Joe Scordino

WAC 173-340-440 of the Model Toxics Control Act (MTCA) regulation requires that restrictions be placed on the future use and activities at certain cleanup sites where residual contamination remains after completion of a cleanup.

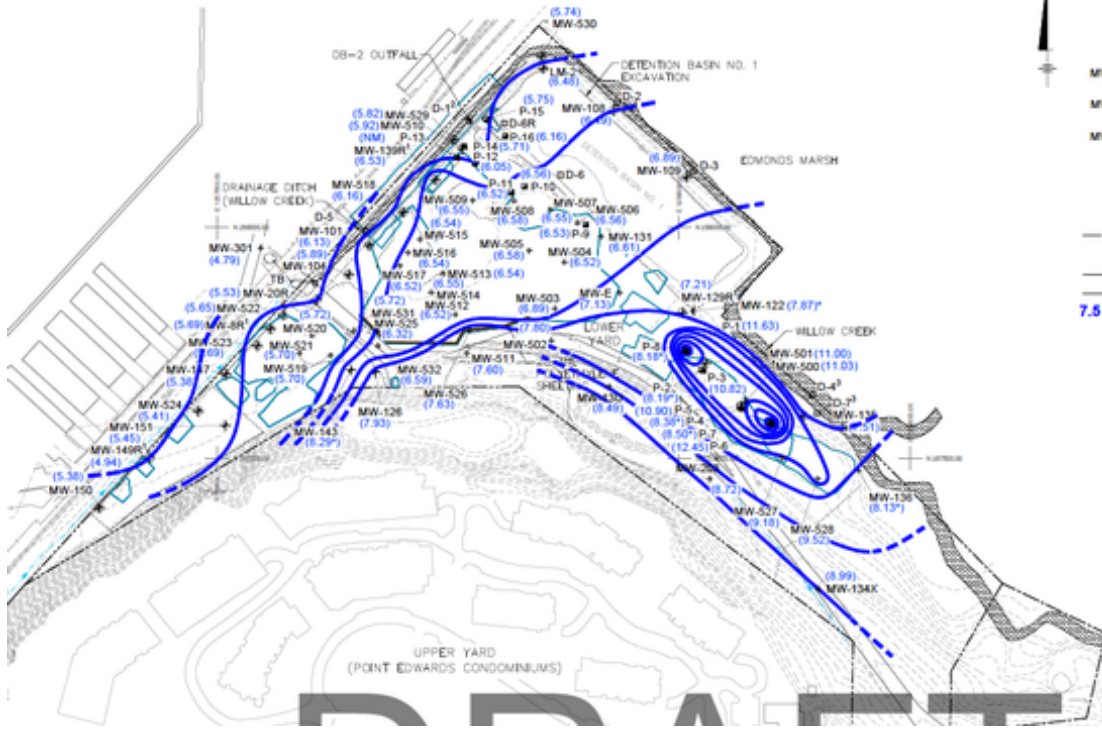
3. What "assurance" (factual information/studies/analyses) is there that the residual contamination around the WSDOT pipe will not "migrate" through groundwater to other locations? See attached map showing large groundwater elevation area in vicinity of WSDOT pipe contamination.
